# Product Change Notification (PCN)

Note: While responding, please retain "**PCN Notification:510583**" in the e-mail Subject line for faster response.

## Before Change

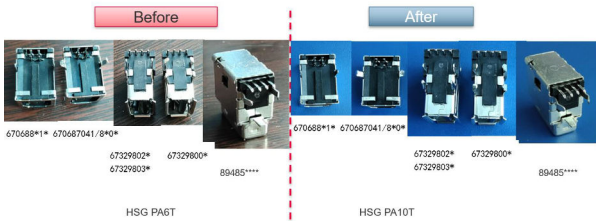
- Due to the resin PA6T global shortage, In order to avoid production line shutdown, We plan to add new resin option PA10T, The surface status as below picture

- Due to the resin PA6T global shortage, In order to avoid production line shutdown, We plan to add new resin option PA10T, The reason of choosing PA10T as below:
  - After the technical parameters compared of PA6T and PA10T, the properties of plastic materials of PA10T is enough to replace and meet the functional application of USB series;
  - The appearance and performance will not be affected for use PA10T.

- Product Impact**  
It has no impact to fit, and function
